INTEL Auburndale BGA with IBEX core logic

Swatch UMA

LA-5251P

KAT10 from PV-R to Pre-MV LA-5251P REV:0.8 -> 0.9 Modify <2009.12.29.~2010.01.05. >

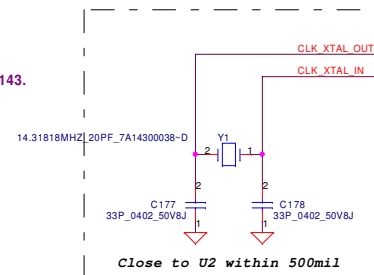
Low Power Chip: Install R120 and remove R143.
Standard Power Chip: Remove R120 and Install R143.

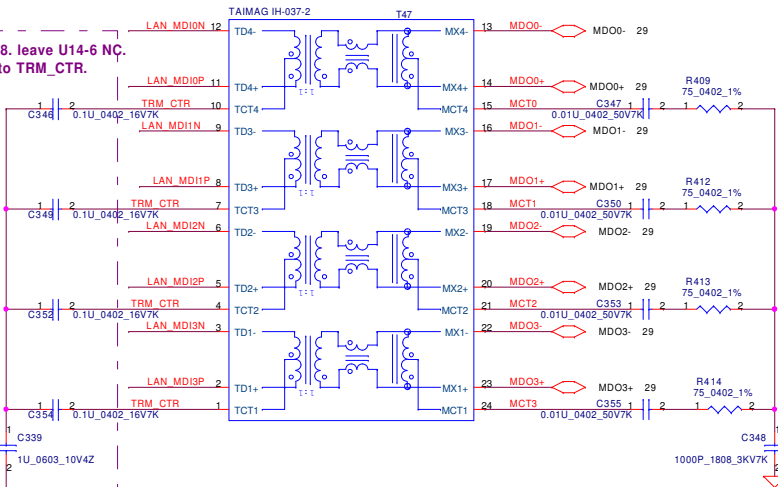
04/25 Delete TRM_CT,R407,R408. leave U14-6 NC.
Add 1uF C339 decoupling cap to TRM CTR.

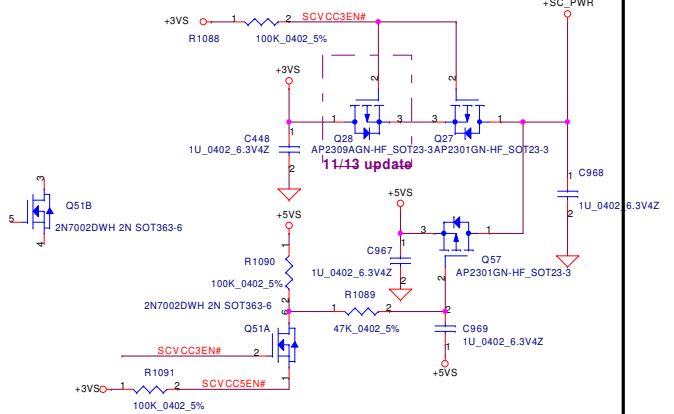
04/23 Add Q28 to prevent +5VS from leaking through Q27.

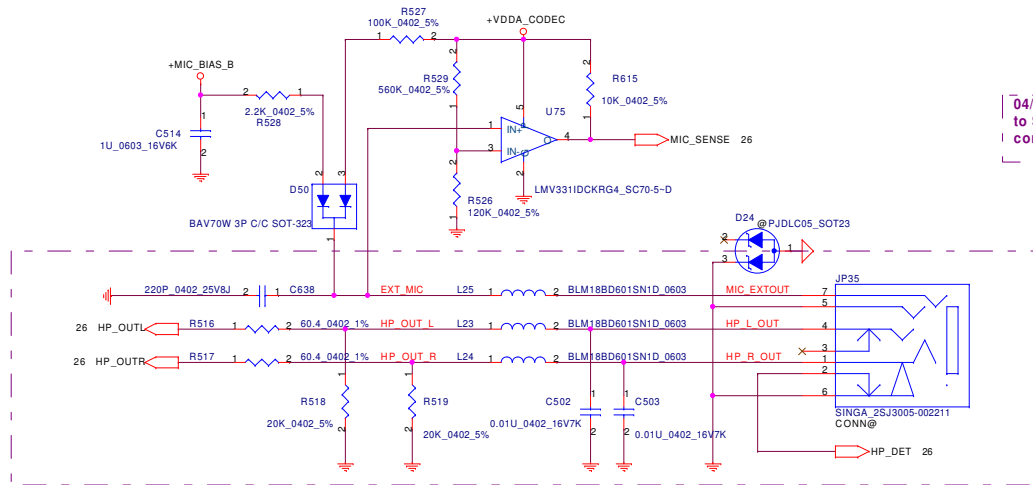
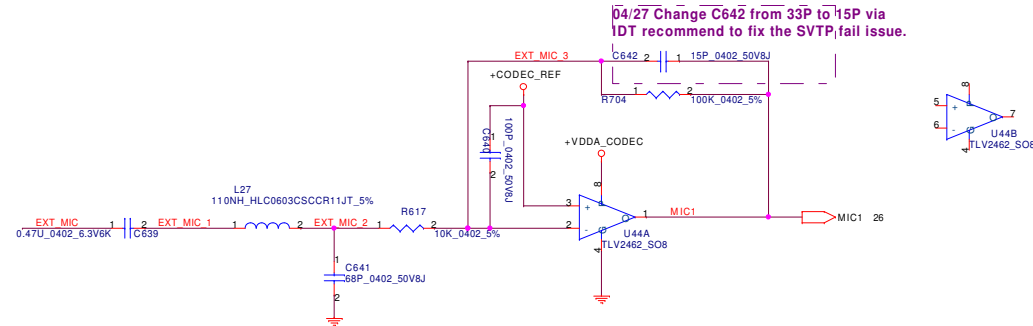
04/24 Correct the Symbol from SINGA_2SJ-B960-003 to SINGA_2SJ3005-002211, also correct the connection for fix Audio work abnormal issue.

Old	New
1HP_L_OUT	1HP_R_OUT
2HP_R_OUT	2HP_DET
3GNDA	3DUMMY net
4MIC_EXTOUT	4HP_L_OUT
5DUMMY net	5GNDA
6HP_DET	6GNDA
7GNDA	7MIC_EXTOUT

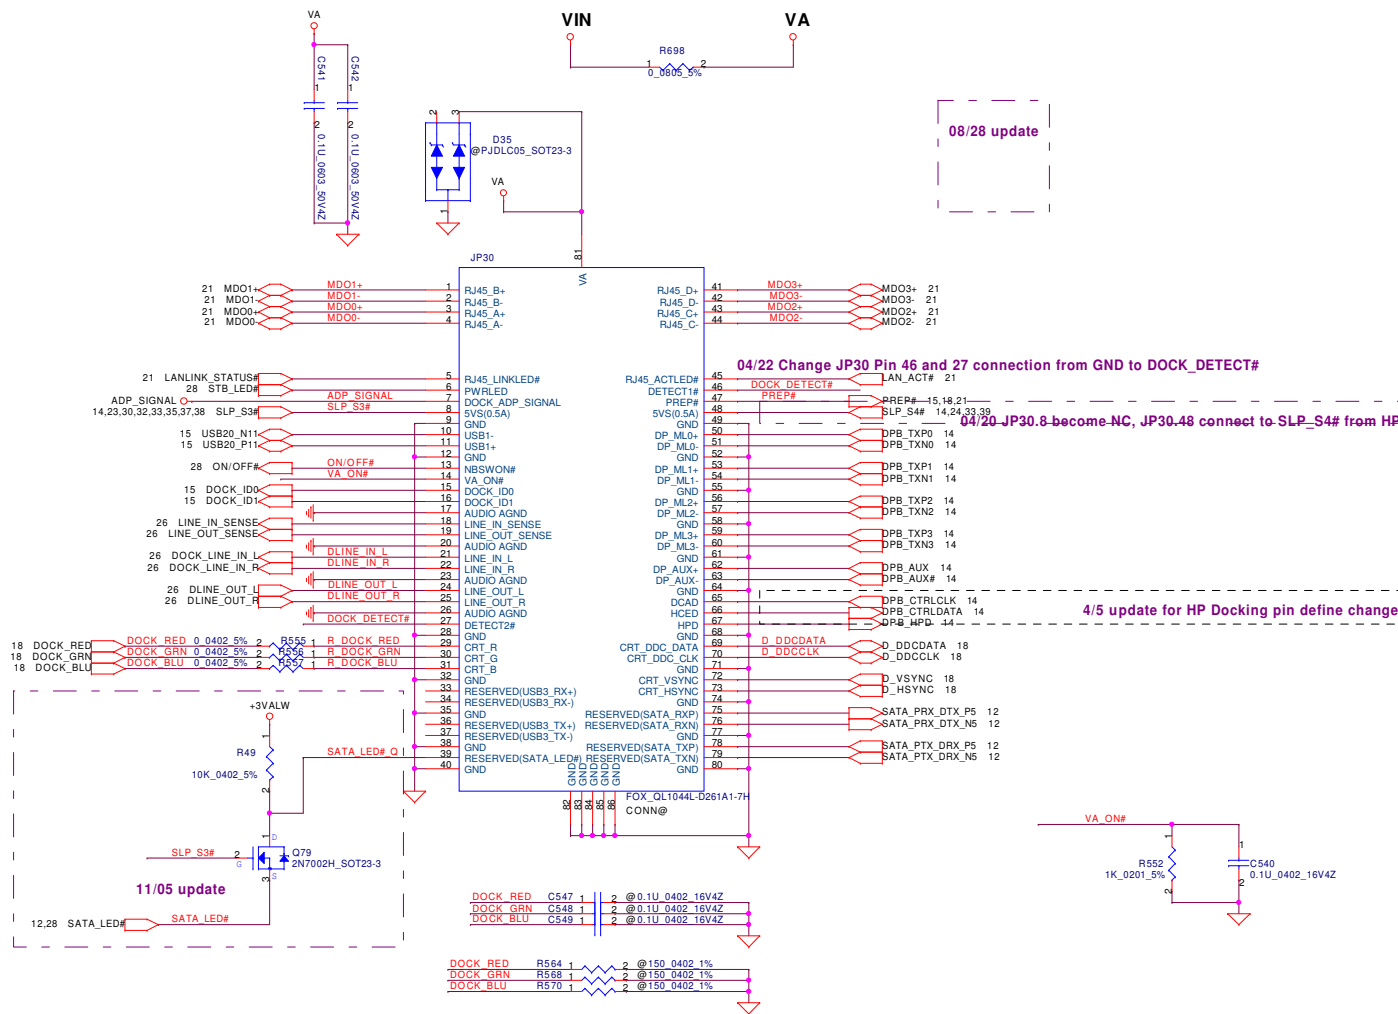
04/27 Change C642 from 33P to 15P via IDT recommend to fix the SVTP fail issue.

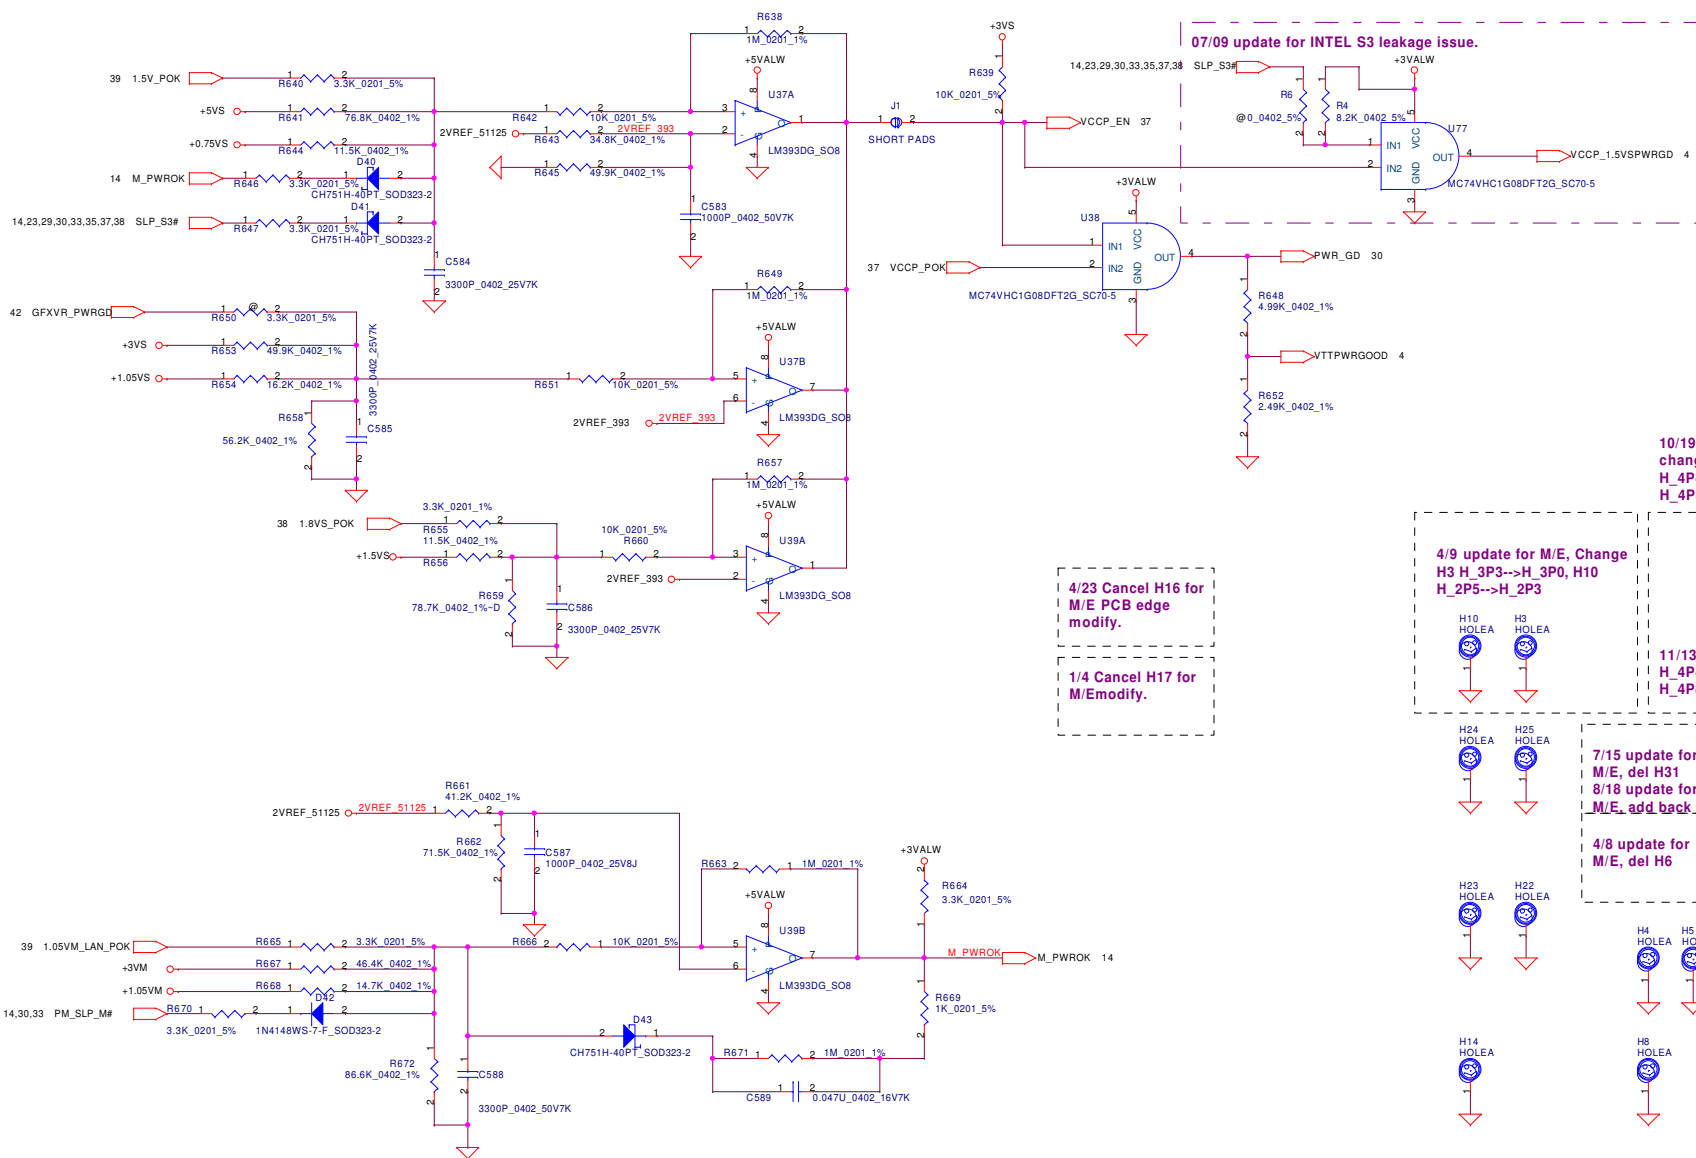
07/09 update for INTEL S3 leakage issue.

4/23 Cancel H16 for M/E PCB edge modify.

1/4 Cancel H17 for M/Emodify.

10/19 Delete H13 (H_3P0); change H2 from H_4P7 to H_4P4; H28 from H_4P9 to H_4P8.

4/9 update for M/E, Change H3 H_3P3-->H_3P0, H10 H_2P5-->H_2P3

11/13 Change H2 from H_4P4 to H_4P7; H28 from H_4P8 to H_4P9.

7/15 update for M/E, del H31
8/18 update for M/E, add back H31

4/8 update for M/E, del H6

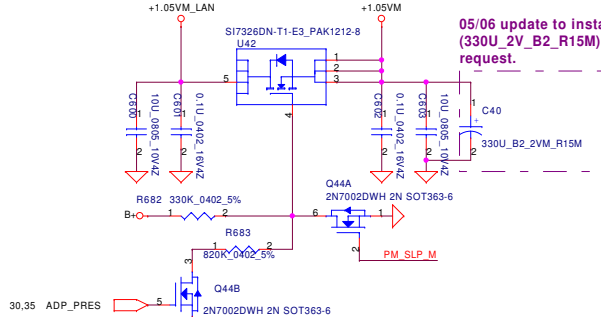
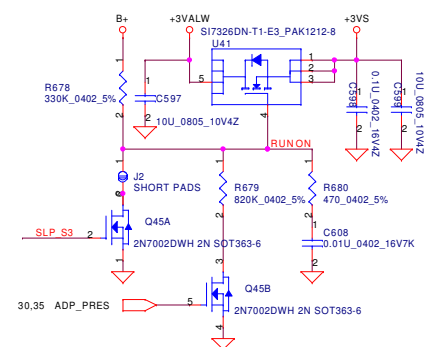
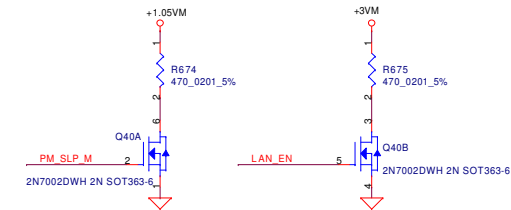
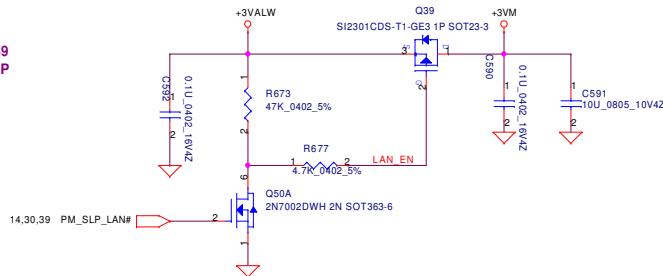
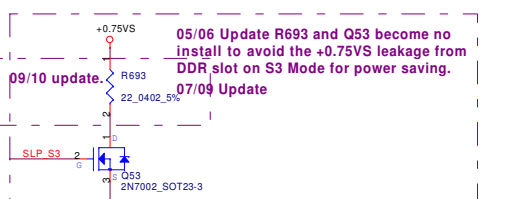
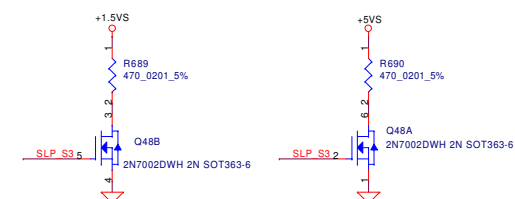
05/06 update to install C39 (330U_2V_B2_R15M) by HP request.

⚙ Add C626,C664 close to JDIMA1; C656,C657 close to JDIMB1.

07/10 update for INTEL S3 leakage issue.

⚙ Add C666,C667,C671 close to JP11.

1/5 update for EMI PCI Issue.

05/06 Update R693 and Q53 become no install to avoid the +0.75VS leakage from DDR slot on S3 Mode for power saving.
07/09 Update
